## APPENDIX 9: COMMENTS RECEIVED ON DRAFT REPORT AND RESPONSE

The tables below provide a collation of comments on the draft report and recommendations – supplied by the Council on 5 April 2024 and updated with our comments. In reviewing the provisions in light of the comments we have made some additional very minor typo and clarity amendments.

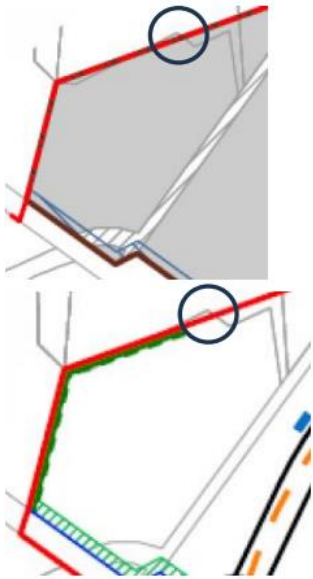
13.4(a) / updated structure plan to include the AHFT Extension Area.	AHFT	<p>Detail of inclusion of the AHFT Extension Area – Internal local road alignment proposed by Council in its draft updated structure plan.</p> <p>The Council in its draft updated structure plan originally showed the internal local type road in a similar location as the AHFT plans dated 18 Dec 2023. However the Council's update did not connect to Spence Road, rather it only</p>	<p>The Panel has included, as a specific trigger for K3 in 49.5.10, that there is an "Access intersection from Spence Road". This connection therefore needs to be shown: refer Saddleback version of the updated structure plan.</p> <p>It is understood that the Council agrees with this in light of the specific trigger, which it had overlooked when preparing the draft updated structure plan.</p> <p>AHFT is also concerned that the Council's proposed</p>

Mapping and structure plan			
Paragraph in decision or Zone provision reference	Comment from	Comment about	Proposed change (if any)
		showed the active travel connections to Spence Road.	<p>notation of the internal road was “Local Type <b>F</b>”, which has little or no meaning (either in the Variation or elsewhere in the District Plan), as Local Type F is not a type provided for in the Variation. AHFT would prefer to simply have it identified as “Local Road”, along with an asterisk to show that the location has flexibility.</p> <p>It is also understood that the Council now agrees with this.</p> <p><b>Panel's Comment: Accept in part. The Panel agrees that Type F is not right. Having considered the matter, and the Council's agreement to the reference to a local road in its response table the Panel agrees to it simply being referenced "Local Road".</b></p>
